BUFFALO RUN ACRES SUBDIVISION

CONSTRUCTION DOCUMENTS TAYLOR CITY, WEBER COUNTY, UTAH

BUFFALO RUN ACRES SUBDIVISION
CONSTRUCTION DOCUMENTS

CE2-02

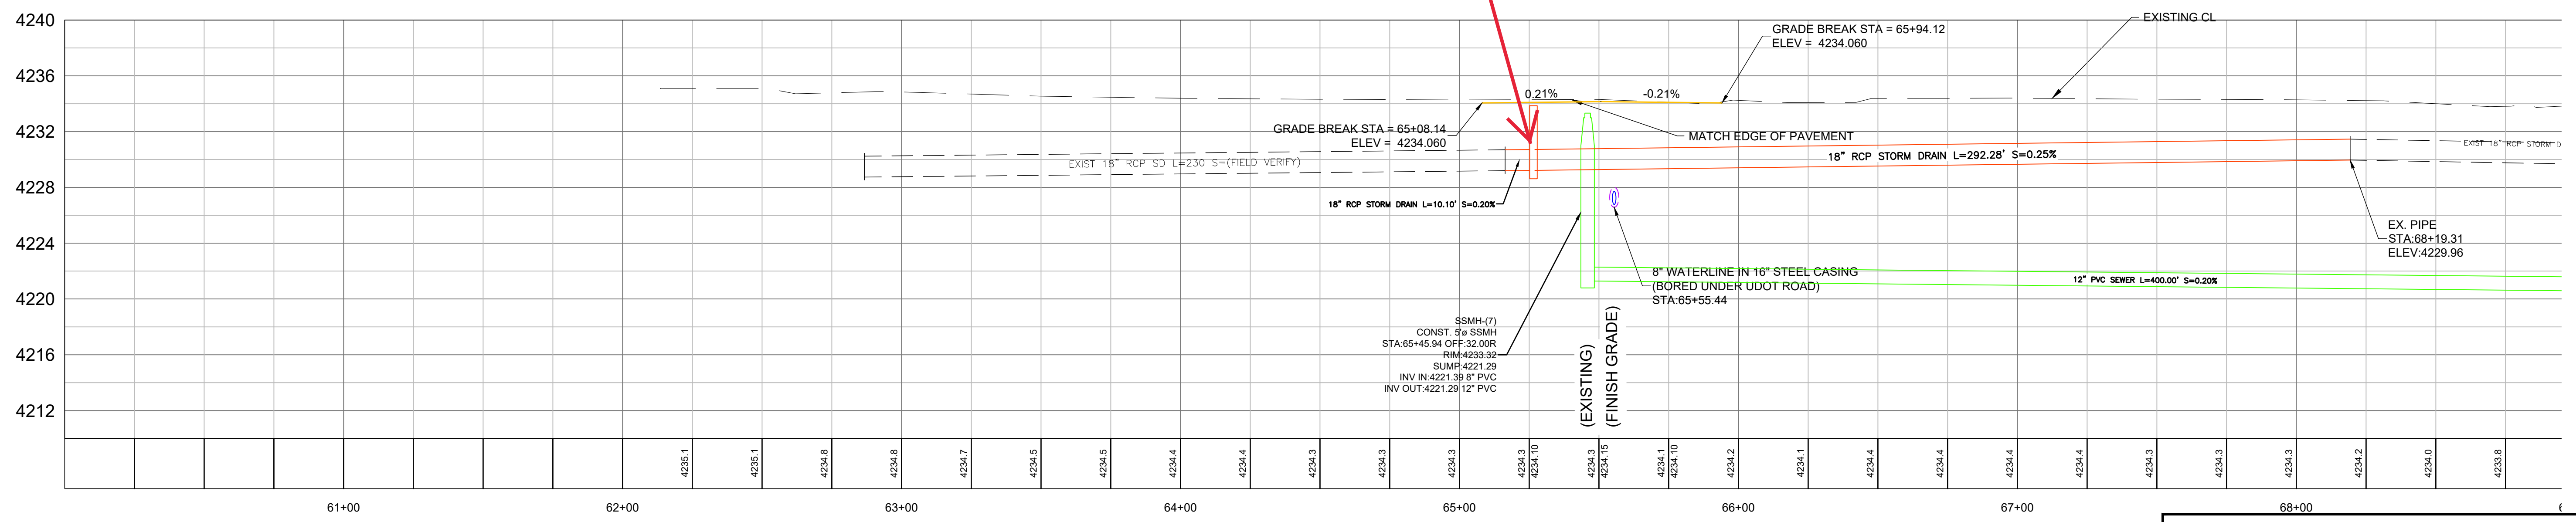
Details on box?

CE2-03

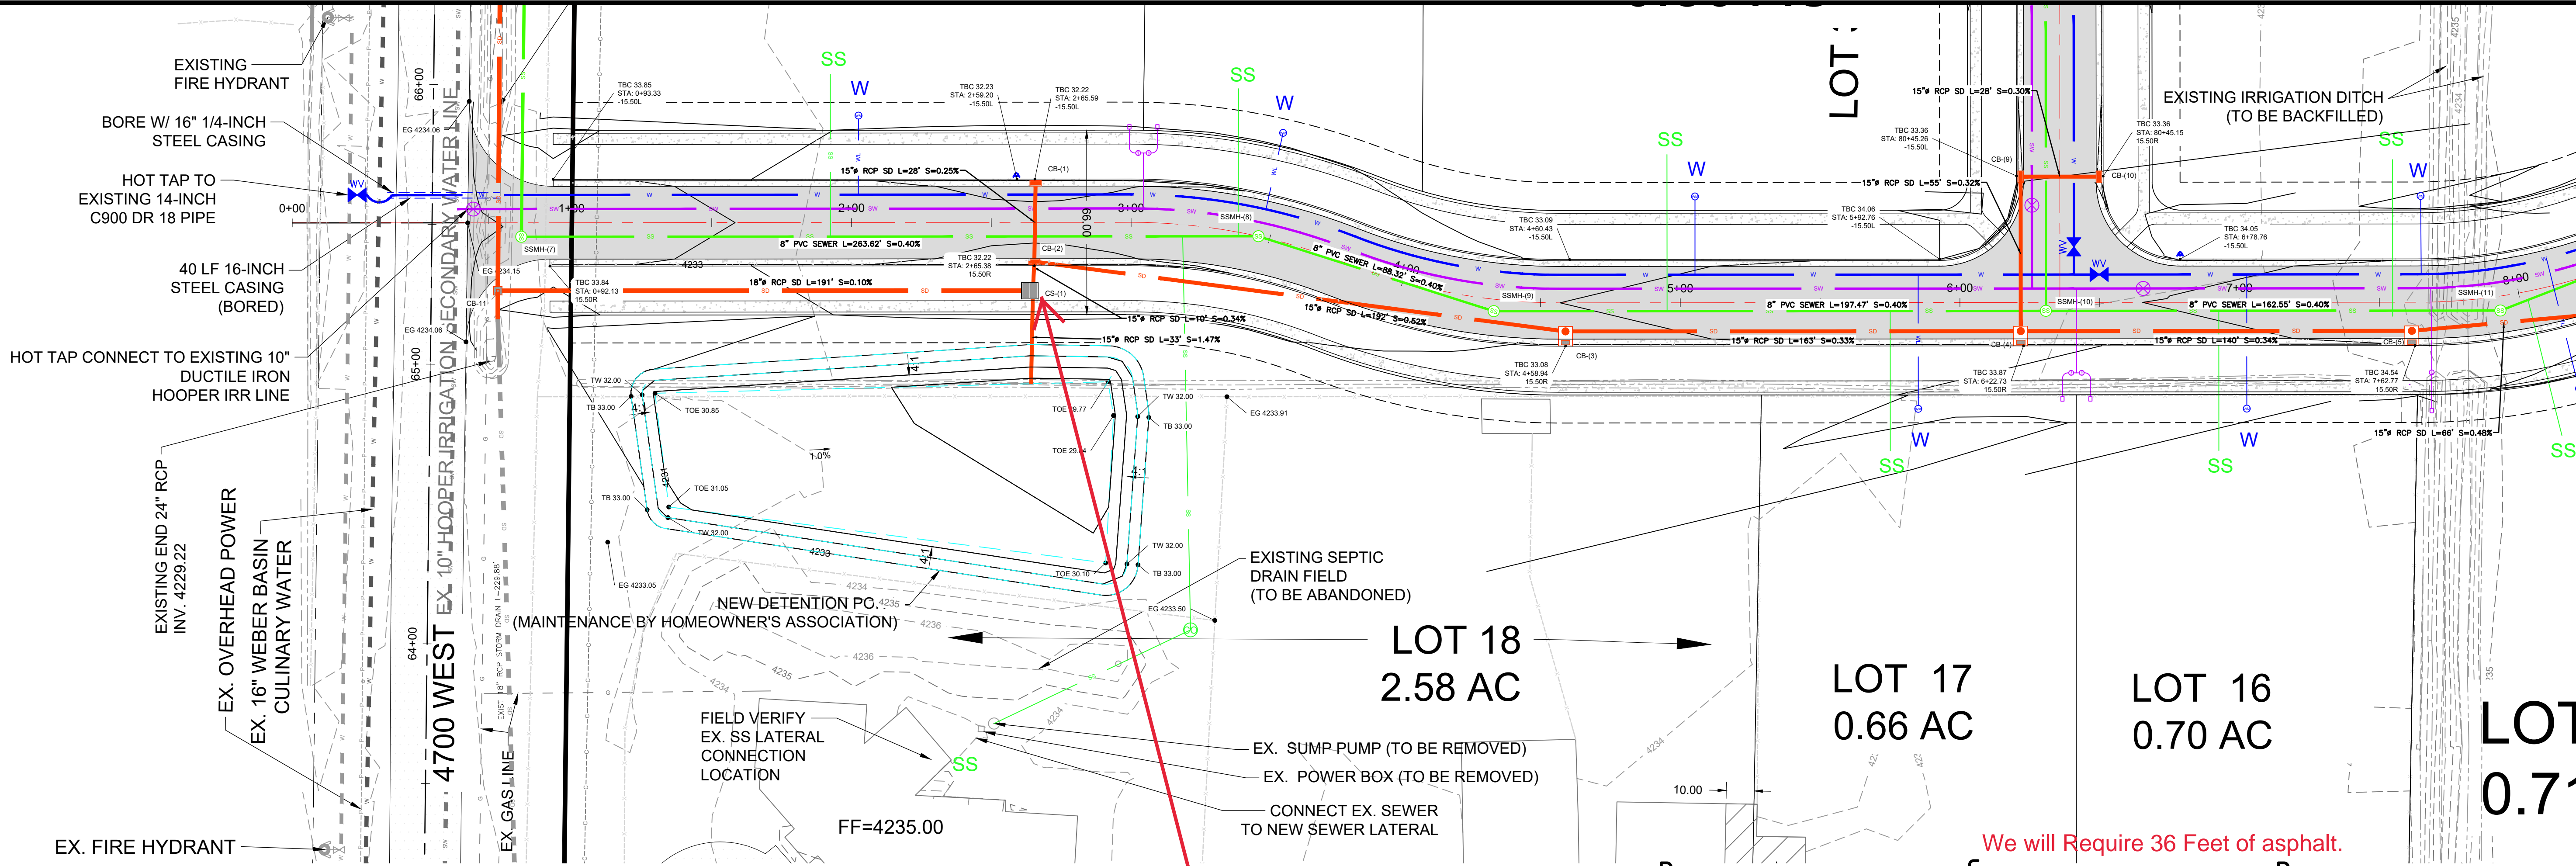
We will Require 36 Feet of asphalt.

CE2-04

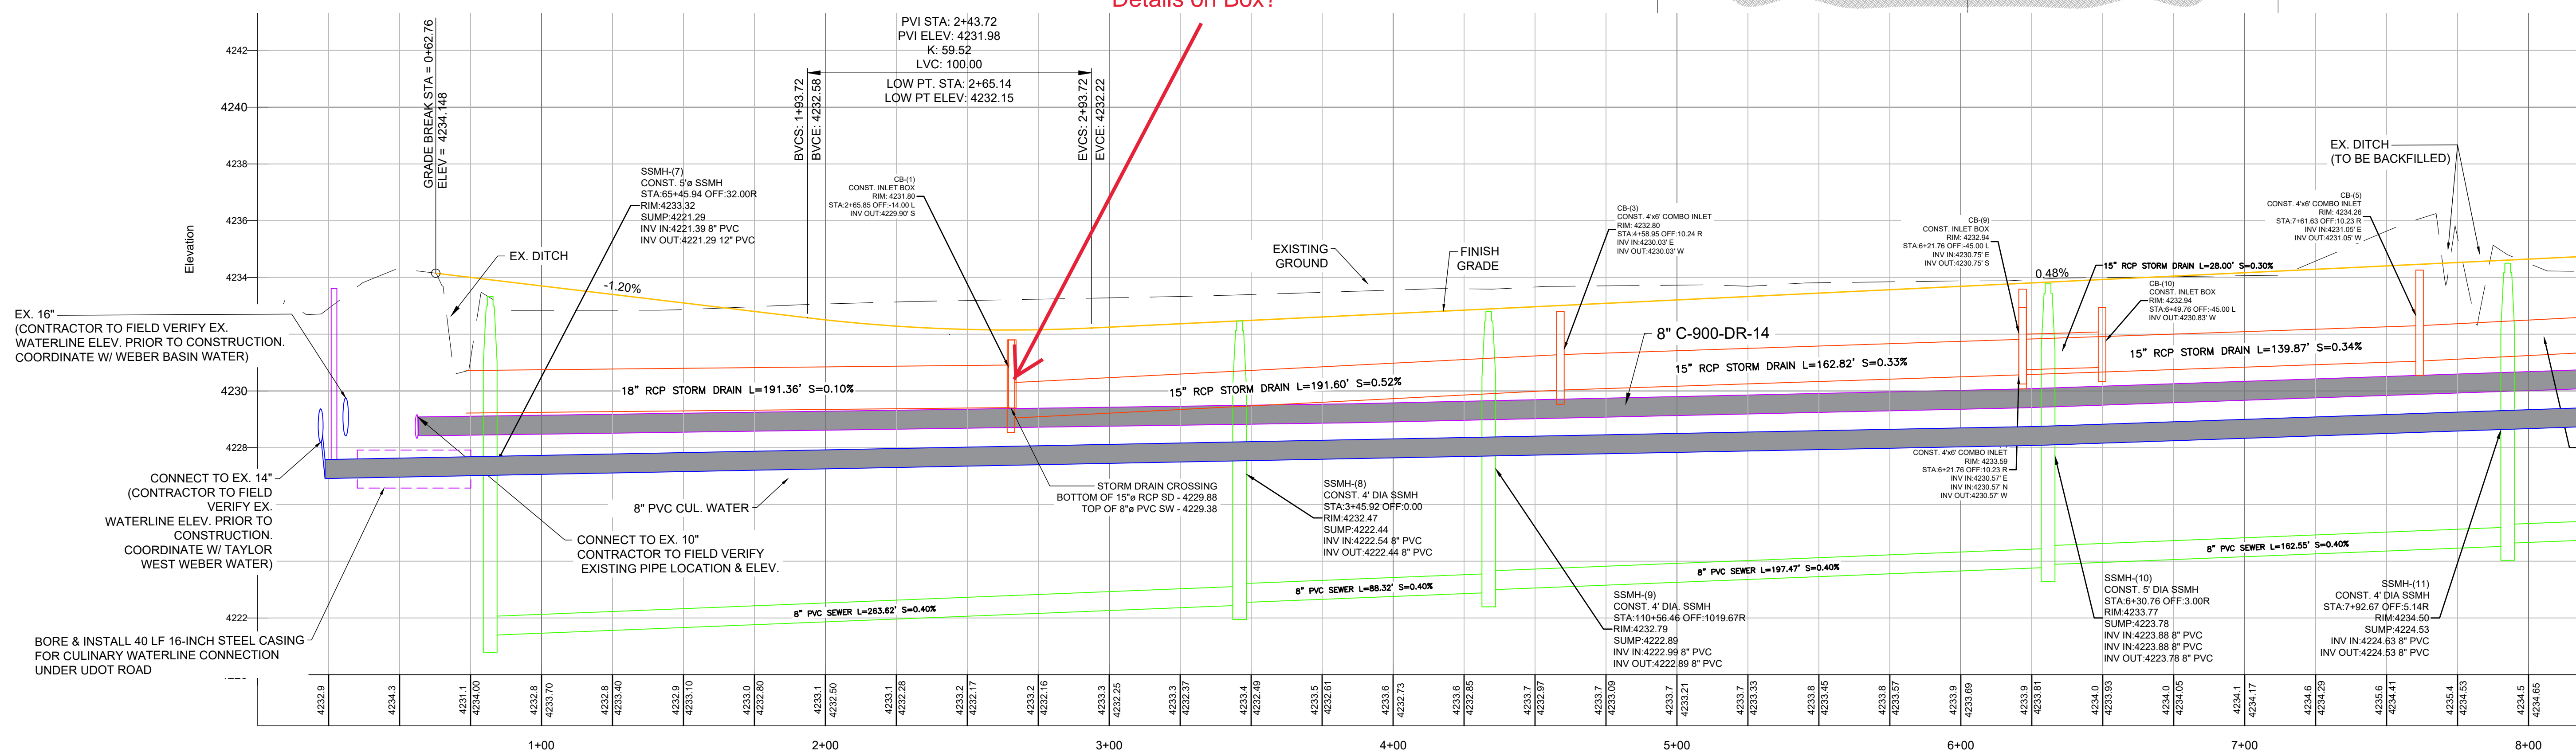
Details on Box?

DETENTION CALCS

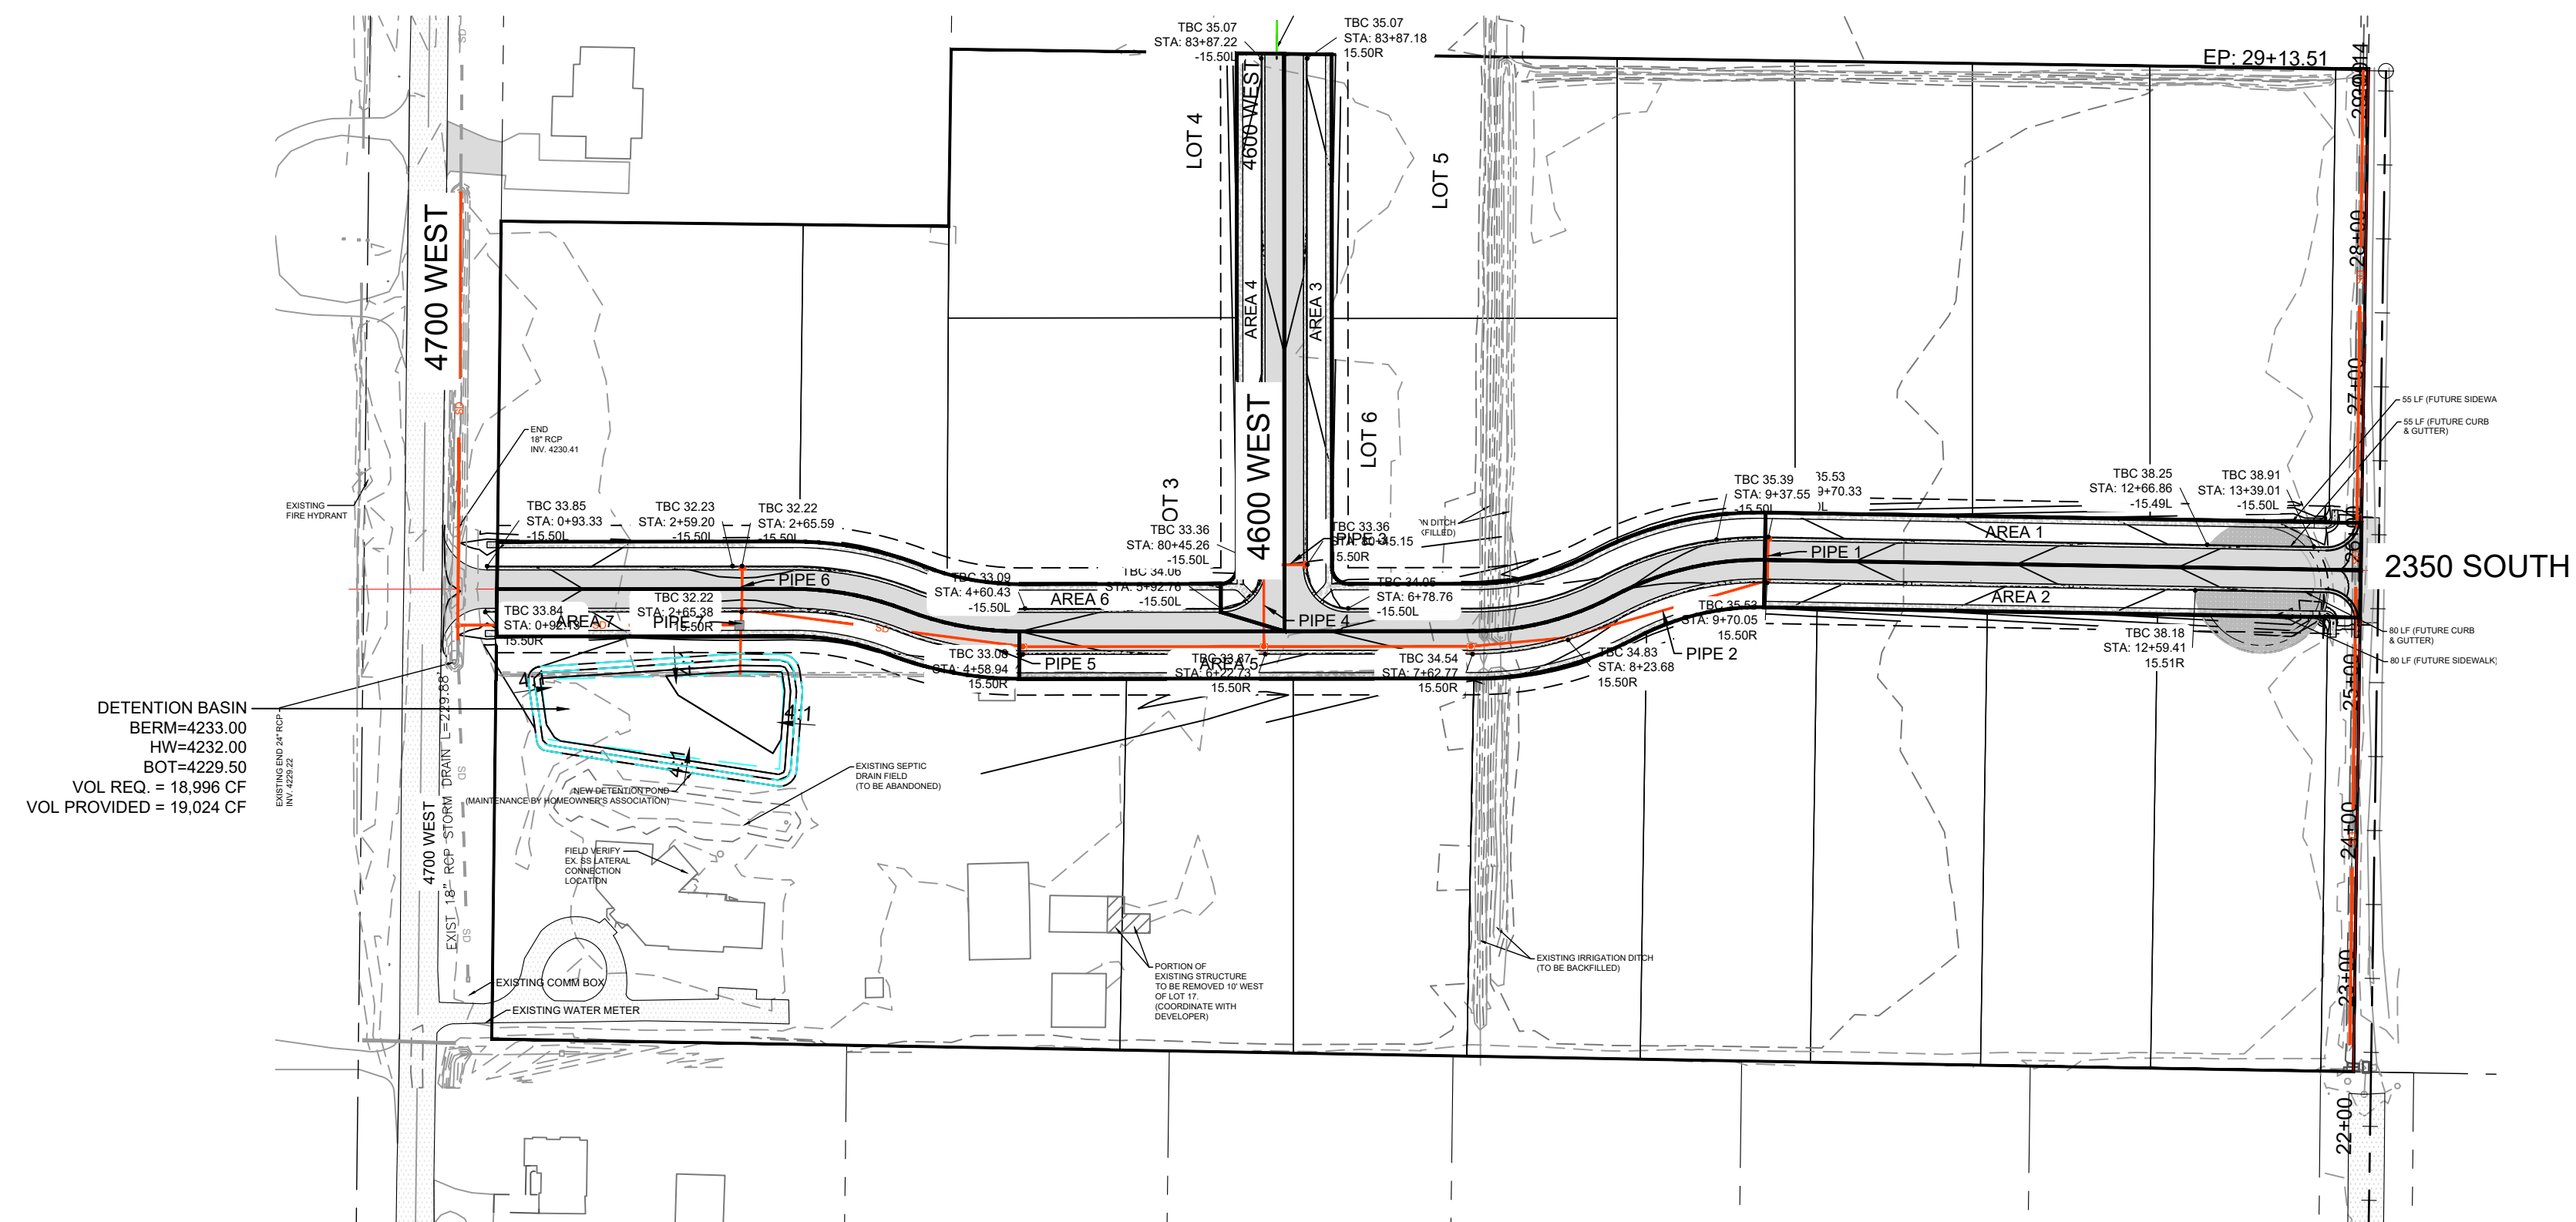
Is this an existing ditch you are piping?
 What is the ditch used for? Is it a tail water ditch?
 We will probably want to see some boxes placed in this line.
